January 17, 2024 – **Revised 2-27-2024**

Re: **Emergency Chlorinator & Oak Grove Spring Intertie – PR# 13-2021**
Ice Fountain Water District – PWS # 00387
Final Approval

Plans and bidding/contract documents related to the above project were submitted to our office on January 28, 2021 and an \$825 plan review fee payment was received on January 25, 2021. On January 15, 2024, I received the *Project Final Approval Request Form* verifying that the above emergency chlorination system and related intertie work was completed March 2, 2021, and has been operational since February 16, 2021, however, has not yet needed to be used. This verification completes the plan review requirements.

3) Oak Grove Spring Valve Vault (see clarification on final configuration on last page):

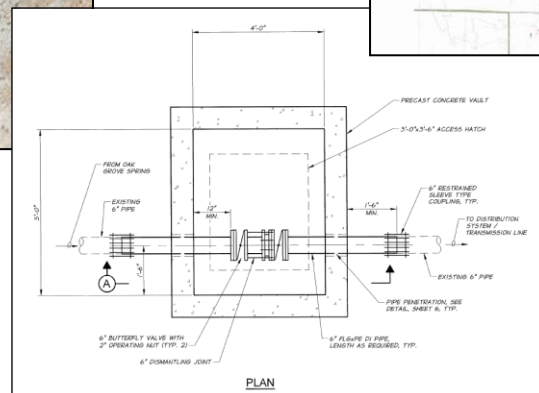
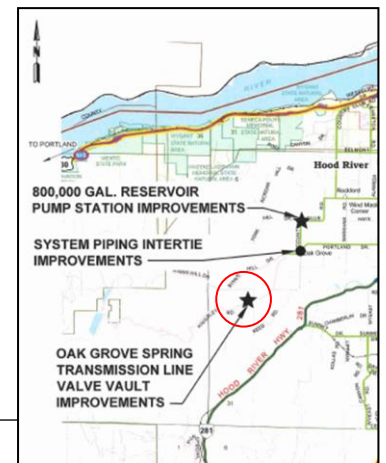
The changes to the vault include moving the butterfly valves outside of the vault and changing the vault to a manhole. However, the constructed improvements provide the same intent as what is shown in the submitted plans shown to the right.

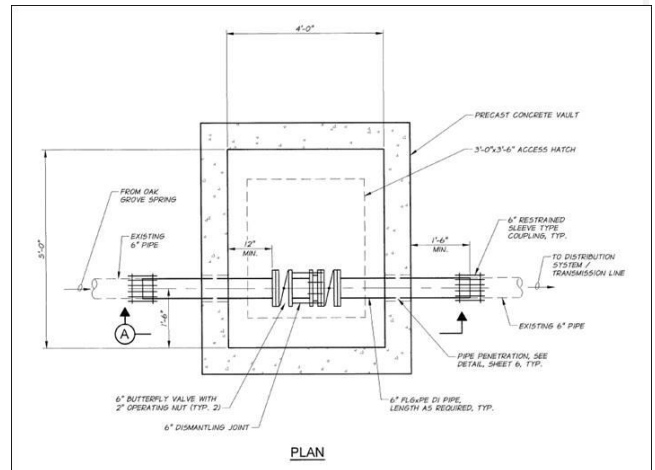
- 1) From what I can tell, the Oak Grove spring (an e-coli contaminated source) is connected to the distribution system with two butterfly valves preventing the flow of water from Oak Grove spring from entering the distribution system with a dismantling joint in between (no blind flange). Does the dismantling joint between the two valves enable them to install a blind plate flange? We do not allow this type of connection without such a blind plate or air gap. I cannot approve the spring connection/emergency chlorination without a blind plate or air gap. **I guess I misspoke in a previous email when I said nothing changed during construction from what was shown on the design drawings. The design of Oak Grove connection vault did change. I believe everything else generally was constructed as shown on the drawings. The changes to the vault include moving the butterfly valves outside of the vault and changing the vault to a manhole. However, the constructed improvements provide the same intent as what is shown in the below drawing. The drawing shows what the system would look like when the District is using the Oak Grove spring during an emergency. During normal operating conditions, the dismantling joint is removed providing an air gap between the Oak Grove spring and the system. There are blind flanges installed on the ends of both pipes that protrude into the manhole that must be removed prior to the dismantling joint being installed to allow use of the Oak Grove spring.**

- 2) As I understand it, there are also services and distribution piping between the spring source and the point of chlorine injection from the emergency chlorinator system. Although, the emergency chlorinator system affords a higher level of protection for the bulk of the water system, the distribution piping and a few services would be exposed to potentially e-coli contaminated water and would therefore, need to be on a boil water notice and that line would need to be flushed and tested prior to allowing that system to be placed into service, even though the 600,000 gallon provides adequate contact time for disinfection. This does not affect the plan review, but is something that will be mentioned in the plan review letter and I want to be sure we are in agreement. **Understood. This was discussed with the District during the design, and they are aware of needing to place those customers on a boil notice in the event that they use the Oak Grove spring. During design, we looked at placing the chlorinator closer to the source. However, due to the pipe size, it appeared there wouldn't be sufficient contact time between the injection point and the customers that you note above that will have to be on a boil notice. Thus, the noted customers would still have to be on a boil notice if the chlorinator had been installed at the source. Additionally, if I remember correctly, there isn't any existing infrastructure (i.e., power, buildings, etc.) near the Oak Grove spring and constructing the chlorinator at the spring would have been significantly more expensive with little to no gain since the same number (or more) customers would still be on a boil notice.**

Systems that have emergency sources will typically cut and cap these connections and place a removable spool in between to maintain the bolt alignment. Then when needed, they remove the spool and insert a pipe to make the connection, at which time, the entire system would be on a boil water notice until the connection is removed, system disinfected and flushed, and coliform sampling results are absent of bacteria.

The below photo is of the Oak Grove connection vault during construction. See below for additional information regarding the vault in red. To my knowledge, when this picture was taken is the only time that the dismantling joint has been installed. After everything was fit together, the dismantling joint was removed, and a blind flange installed on each pipe, and there is an air gap between the source and the system. Chris may be able to provide a photo of the current configuration, I couldn't find one in our records.
